Errata Document

A. This document details the limitations of the cascading option of the AD73360 due to a bug in the current silicon.

Rev.A 6-2000

Figure 2. Cascade Timing for a Three-Device Cascade

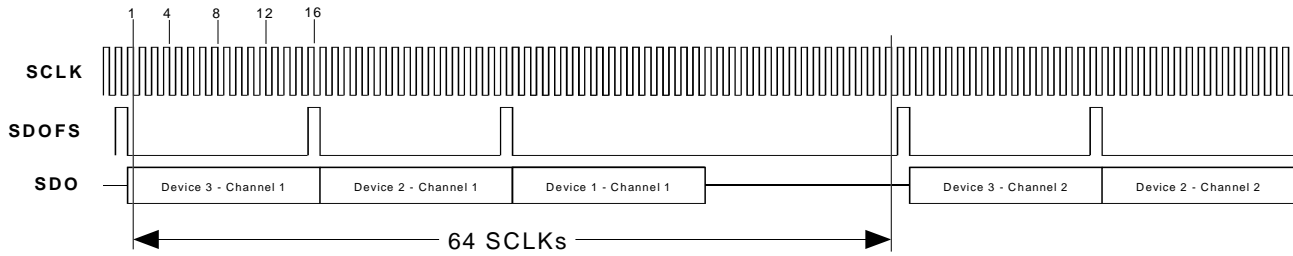
For cascades of more than two devices the AD73360 will leave too many SCLKs between transmitting channel information. This increases the time it takes to transmit the ADC data and since a DSP or microcontroller must read data from all the ADCs in the cascade in one sample period the number of devices which can be cascaded will be limited. Figure 2 shows the effect the additional SCLKs have on a cascade of three devices.

For a cascade of a given length, the SCLK rate and Sample Period will determine if the cascade can be used successfully. A low sample rate will allow more time for the ADC data to be read. Similarly a high SCLK rate will transmit the data in a shorter time. Since both the SCLK rate and Sample Rate are derived from the same DMCLK the number of combinations is limited. As most applications will require a predetermined sample rate, the SCLK speed will be the limiting factor in the cascade length that can be used. Table I shows the maximum cascade length for a given SCLK and Sample Rate. The table assumes that a MCLK of 16.384MHz is used.
